L140-D961589-E-V

PSI DWG # V049-8-149

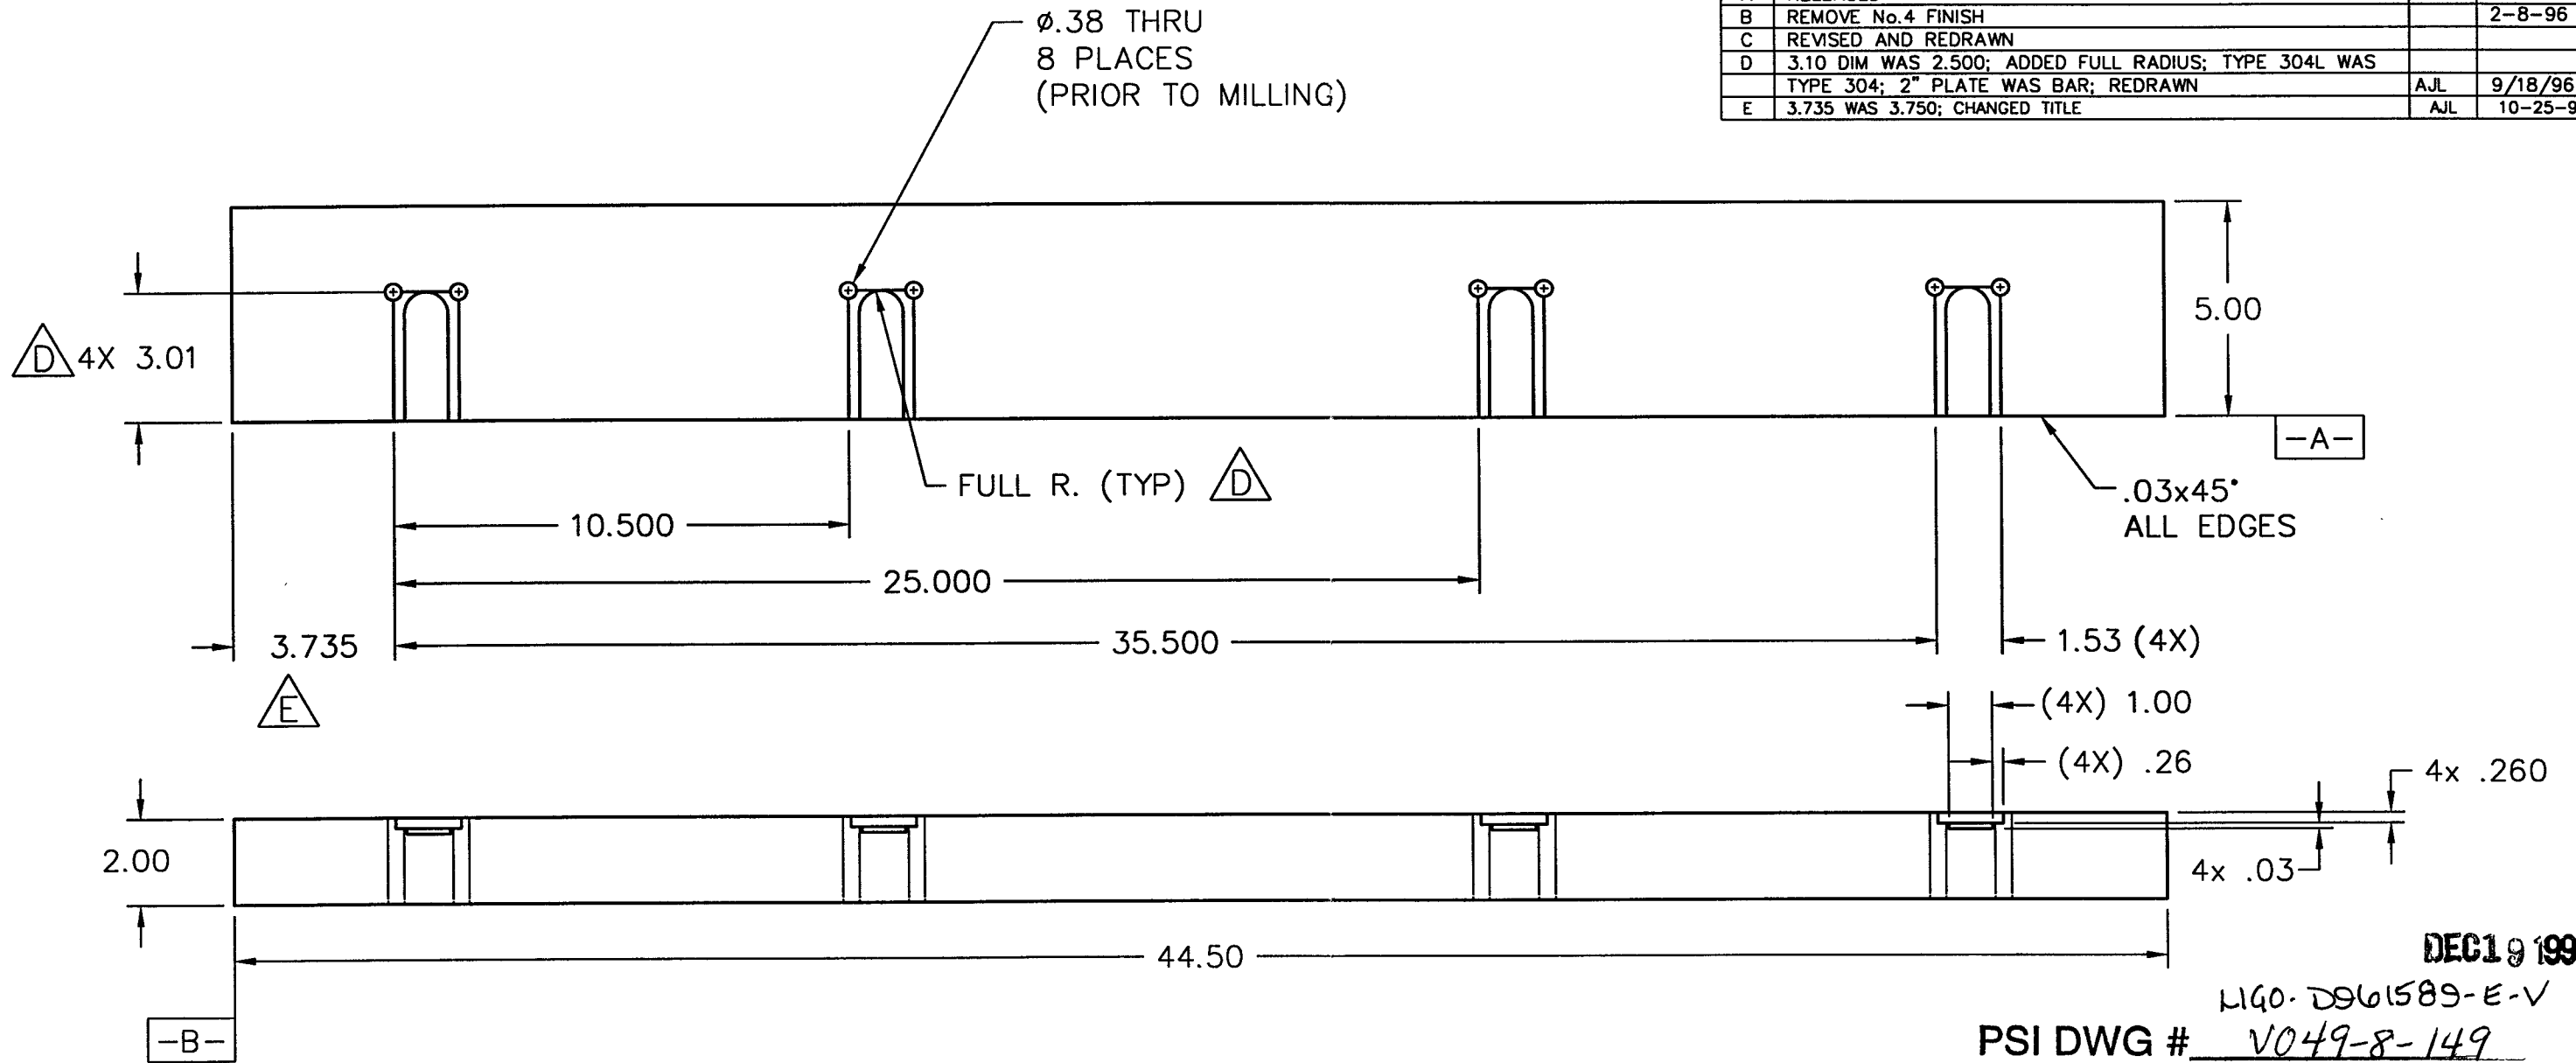
REV.	DESCRIPTION	APPROVED	DATE
A	RELEASED		
B	REMOVE No.4 FINISH		2-8-96
C	REVISED AND REDRAWN		
D	3.10 DIM WAS 2.500; ADDED FULL RADIUS; TYPE 304L WAS		
	TYPE 304; 2" PLATE WAS BAR; REDRAWN	AJL	9/18/96
E	3.735 WAS 3.750; CHANGED TITLE	AJL	10-25-96
